STAFF REPORT: 7/9/2025 REGULAR MEETING
APPLICATION NUMBER: HDC2025-00407-8057
VIOLATION NUMBER: 651
ADDRESS: 691 W. CANFIELD
HISTORIC DISTRICT: WEST CANFIELD
APPLICANT/ PROPERTY OWNER: ROSANNE AND DOUG PATTISON
DATE OF PROVISIONALLY COMPLETE APPLICATION: 6/17/25
DATES OF STAFF SITE VISITS: 6/23/25

PREPARED BY: E. THACKERY

SCOPE: MULTIPLE EXTERIOR ALTERATIONS

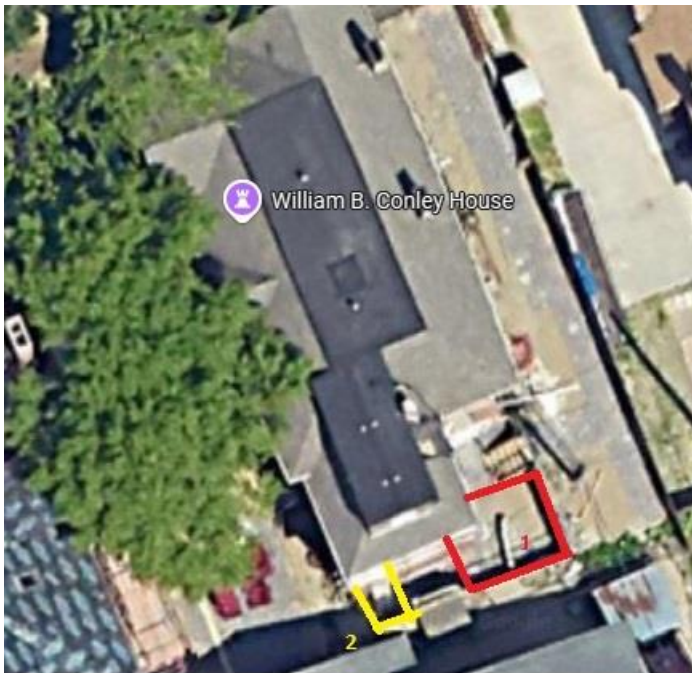
Once the demolition is complete, the applicant proposes to build two a deck and patio at the building's rear (south) end of the house to cover parts of the exposed areaway below. Below, staff outlined one area in red (Deck) and one area in yellow (Porch). These are roughly the two deck areas being proposed. The deck outlined in red will be at grade and will span roughly the area between the two exterior sets of stairs that go down to the basement level—one near the southeast corner of the house and one under the rubble-and-concrete vault-like structure. Because both ends will overlook the trench, both ends need a rail. The porch outlined in yellow will be raised and will cover the trench roughly from the sheltered stone steps west to the house's southwest corner, roughly the area that was covered by the stone steps and stone-and-concrete platform just west of the vault-like structure in the pictures above.

- Leaving the excavated site and foundation fully exposed in this southeast corner to create a walkout basement and sunken patio was proposed in 2022 and was denied by the Commission at that time. The current application revises the 2022 plan for the area by proposing to add a 10’x15’ deck and a patio at grade, which would leave only a small area of the below-grade/sunken patio/areaway visible/exposed.

- Note that when the excavation was complete in the 1940s, it was then covered up. The house had decks and patios at grade. The proposed installation of the new porch and at-grade deck will serve to partially/mostly cover the current exposed trench, bringing the backyard area closer to its appearance prior to the 2022 unapproved work, while it also leaves a small portion of the basement wall exposed and with a large door with sidelights. For reference, below left is how the space over the current sunken patio looked as of the real estate listing in October 2021:

- The new rear deck and patio will either be painted or stained; no unpainted pressure-treated wood will be visible above ground. Also, applicant shall propose a new skirting design for the new rear patio which is more compatible with historic building and the railing for the new deck shall be wood, rather than the proposed aluminum. The final railing design shall be submitted to staff for review and approval.

Figure 2. Applicant provided plan; staff marked it in red.

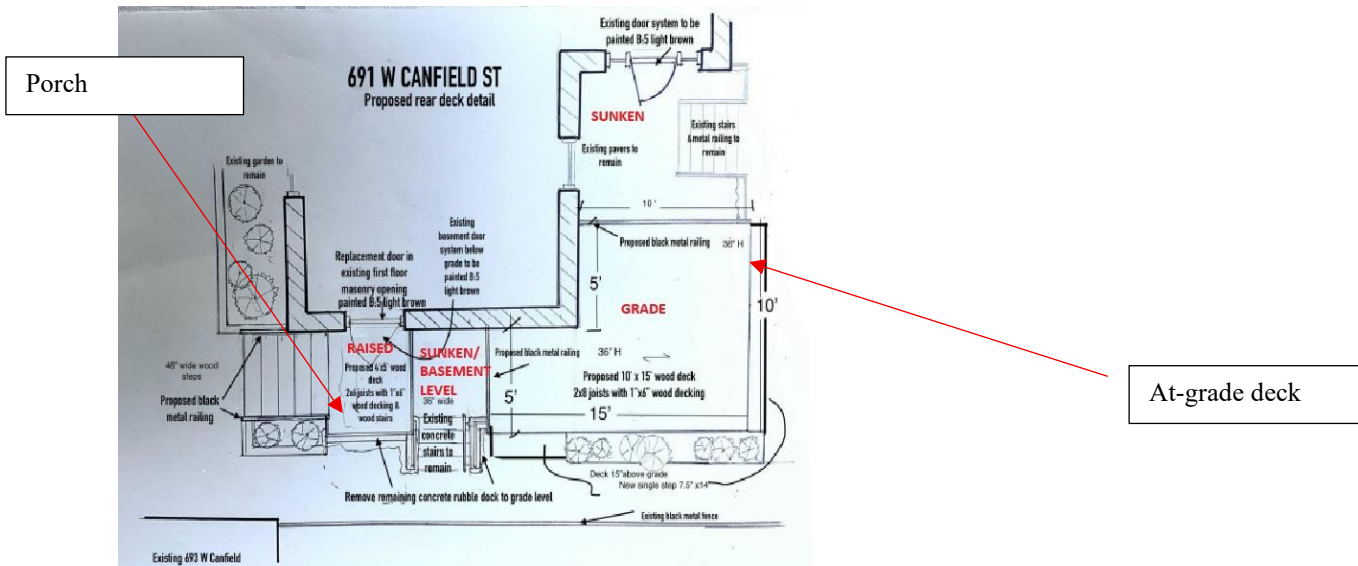
Wood (1" x 8" deck boards) with black metal rail. Steps: 1" x 8" deck boards and metal handrail. Access from the boarded-up door shown in *Photo 7*. A new **door for that opening** is proposed to be a steel door that has a window in half the door and two raised panels below the window. Door is proposed to be painted to match the door with sidelights to the sunken patio near the house's southeast corner.

- Staff believes that the new deck and porch proposed for the rear are appropriate and largely meet the Standards, specifically Standard 9. Staff would, however, recommend that:

- the proposed deck surface be painted or stained to help blend in more with historic materials
 - there be no unpainted pressure-treated wood left visible above ground, and that

- the skirting proposed below the new porch should be less horizontal in emphasis and more compatible with historic screening methods.
 - a different railing type be selected for the deck that has a slightly more traditional appearance and is wood painted to match the house's trim, or possibly wood composite that matches the trim. The current proposed railing is modern and thin black aluminum and would match the current railing (see the above) that was installed without HDC approval.

Figure 3. Applicant-provided proposed rear (south) elevation. Deck and Porch are shown, along with the concrete steps that go down to the basement level

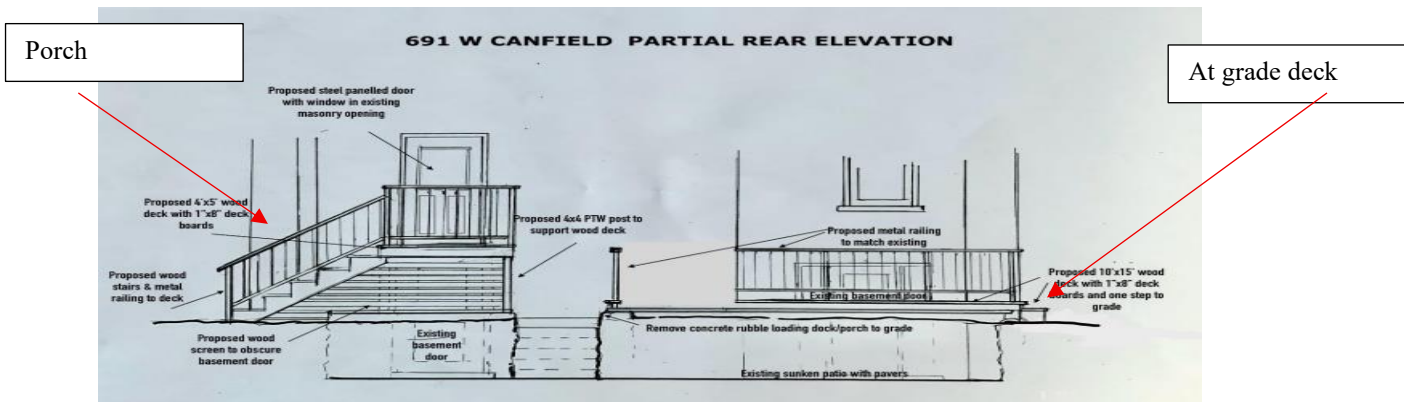
- At the time of this report, staff does not see door product information for the below-grade door with sidelights. Staff cannot comment on its materiality, but it is staff's opinion that the proportions of the door with its sidelights do not match the historic house's proportions. Staff does not see another historic door opening on this house that is as wide other than the front door. Having this rear door almost as wide as (if not as wide as) the front door when it is not an historic opening gives the rear, below-grade door prominence that the Secretary of the Interior's Standards and Guidelines would not support, in staff's opinion, as new work or alterations should be secondary to historic materials and features. However, staff

does find that the door proposed for access to the new rear porch near the house's southwest corner to be appropriate, meeting the Secretary of the Interior's Standards and Guidelines.

- The material of the window wells and the door at the rear façade, basement level shall be compatible with the building's historic character, as determined by staff
